Product Change Notification (PCN)

PCN Number	511248	Date Issued	December 02, 2021
Reason for Change	Manufacturing Process Change (Molex)		
Change Type Description	This letter is to inform you that the manufacturing process for the part(s) identified in this notice is changing. No changes will be made to the product as a result of this process change.		
Assessment of Change	Product will be fully qualified before it is shipped. Qualification reports will be available after below listed date		
Internal Molex Qualification Date	March 18, 2022		
Sample Availability Date (Changed Part)	March 18, 2022		
Planned Implementation Date	May 12, 2022		
Method of Identifying Change	No special marking on the product or packaging

Before Change

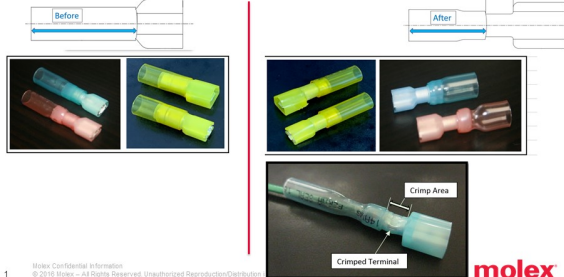
- Example of Fully Insulated Male Coupler Quick-Connect Terminal Connectors with Heat-Shrink Tubing not in the conductor crimp area.

- Molex is realigning (shorten) the Heat-Shrink Tubing in order to provide a clear crimp area over the insulated conductor barrel. This will impact Perma-Seal Coupler Quick-Connects, Red 22-18 awg, & Yellow 12-10 awg.

- There's No Impact in overall length, fit, form or function of these products.
 - These terminals are already UL/CSA Certified and crimped without heat shrink tubing in the crimping area.
